## **SECOND FIVE-YEAR REVIEW**

**MALLORY CAPACITOR CO. SITE  
WAYNESBORO, TENNESSEE**

**Prepared For:  
Battery Properties, Inc.**

**JUNE 2003  
REF. NO. 2319 (48)**

Figure 3. Recommended well locations for the shallow zone.

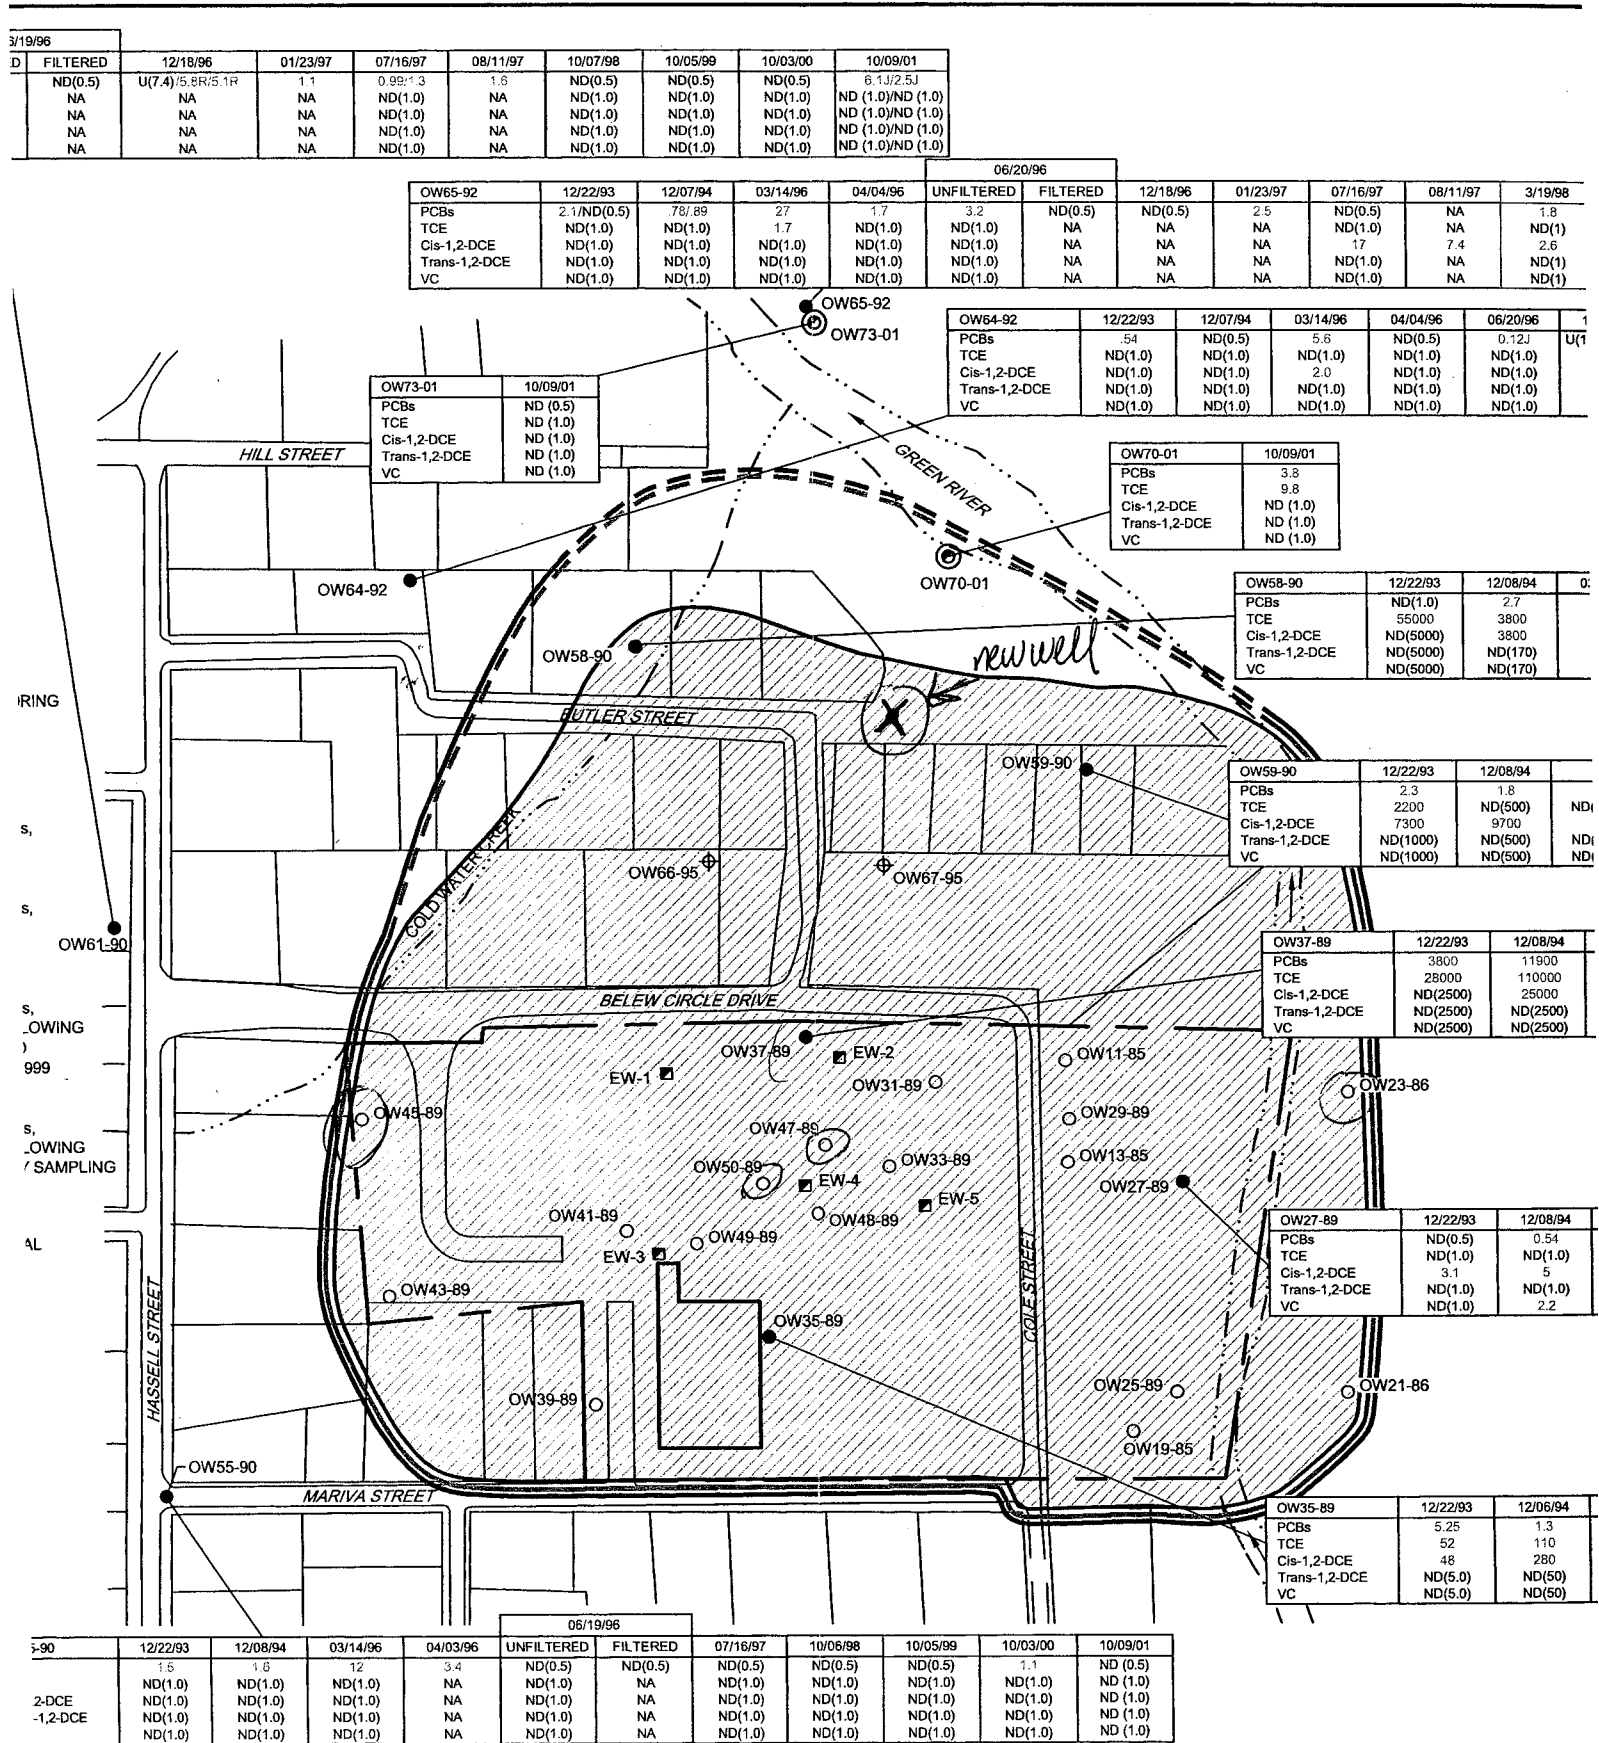
The upgradient area is loosely defined as that area west and south, and in general, upgradient of the source area. Currently the monitoring locations in the shallow aquifer are well outside the contamination plume. In the shallow aquifer, it is recommended that well OW45-89 be included in the monitoring program because of its proximity to the presumed plume boundary as drawn in Figure 4.1 of the 2001 Annual Report. As in the eastern area, monitoring at this location can assist in the evaluation of the effectiveness of the source area actions described above. In the deep aquifer, coverage on the western plume boundary is adequate, but no locations defining the southern boundary are monitored regularly. For this reason, it is recommended that well OW40-89 be included in regular monitoring. Finally, in the deeper aquifer zone, there are currently no wells in this portion of the plume. It may be beneficial to install a single well in this area (approximate location shown on Figure 5) in order to document the extent of contaminant migration in this portion of the deeper aquifer, verifying the contour lines as drawn on Figure 4.3 of the 2001 Annual Report.

new wells as shown on Figures 3, 4, and 5 be installed. These wells will provide the data necessary to evaluate the effectiveness of additional source area activities and will support the evaluation of MNA at the site.

In response to these recommendations, CRA concurred with installing a new off-Site shallow/deep/deeper bedrock monitoring well nest approximately mid-way between the existing shallow wells OW58-90 and OW59-90, considering that this monitoring well nest will improve the understanding of off-Site plume behavior and will aid in the MNA remedy evaluation for the off-Site plume. CRA indicated that, since only low VOC concentrations are detected at OW63-90, installing an additional well upgradient of OW63-90 is not warranted.

USEPA concurred with this response.

Figure 5. Recommended well locations for the deeper zone.

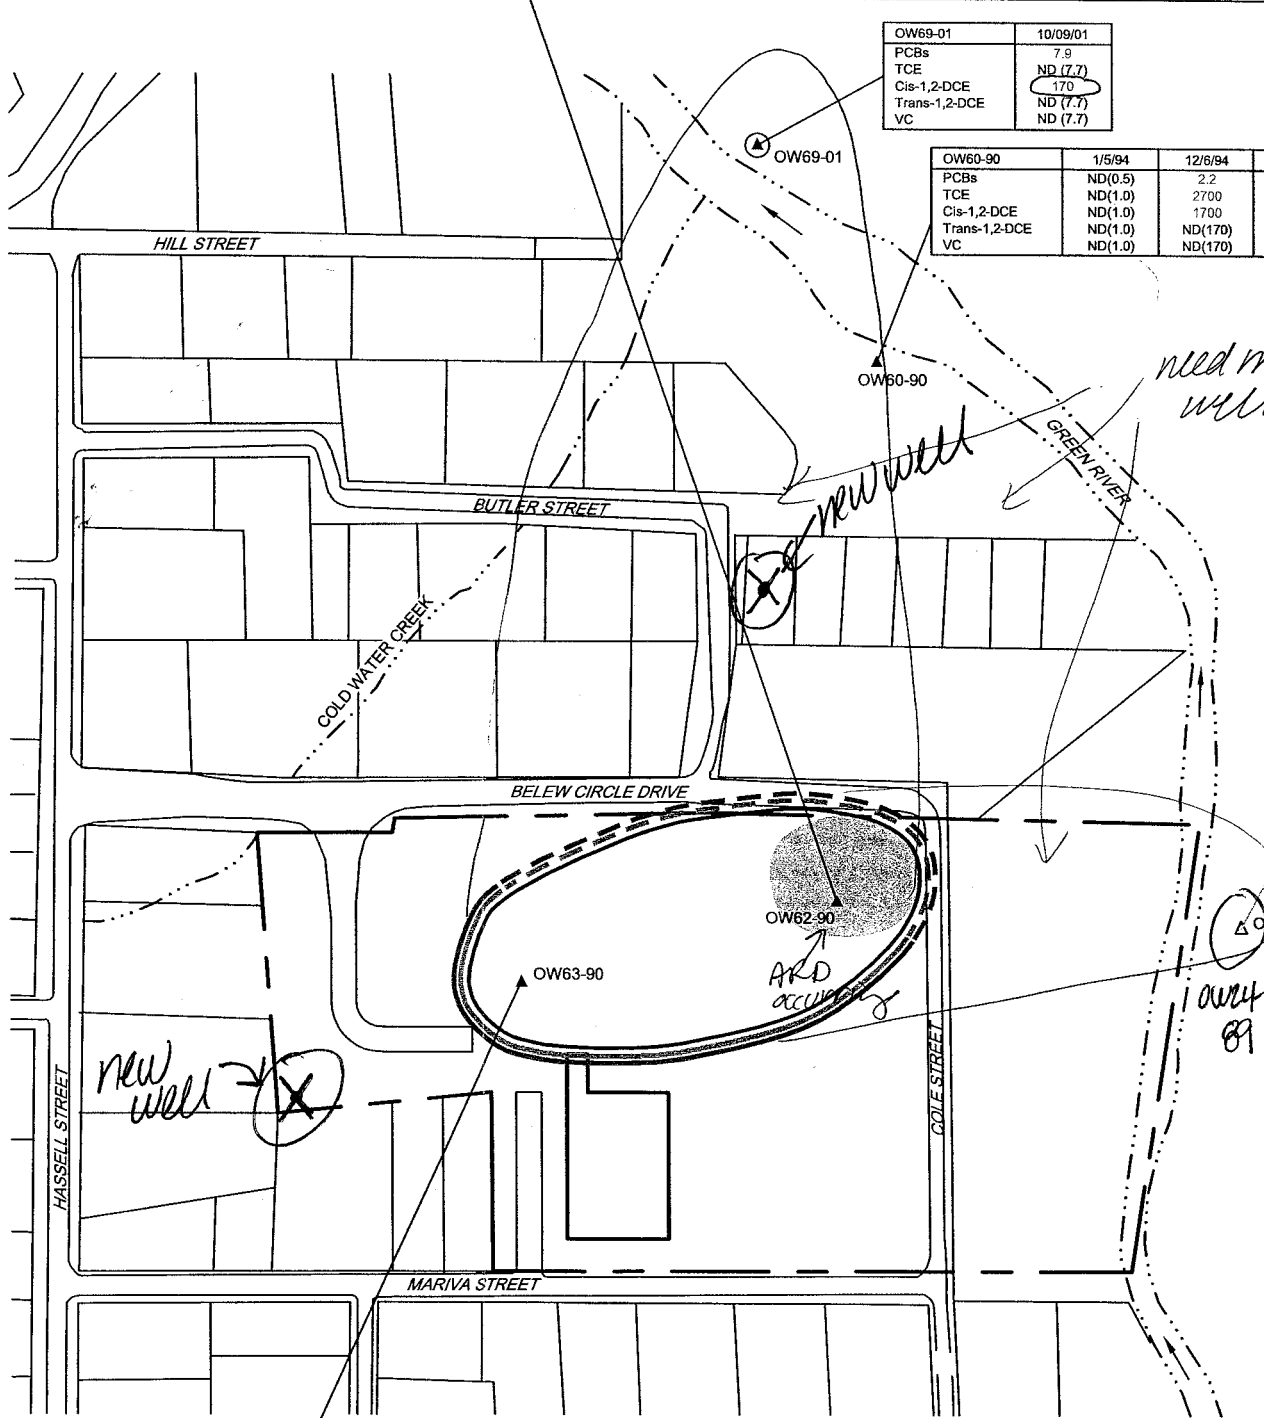
is occurring (as evidenced by cis-1,2-DCE in OW-69-01), it is necessary to document the attenuation of contaminants along the flowpath from the source area. In order to do this, it is recommended that one additional well be installed at the location shown on Figure 5.
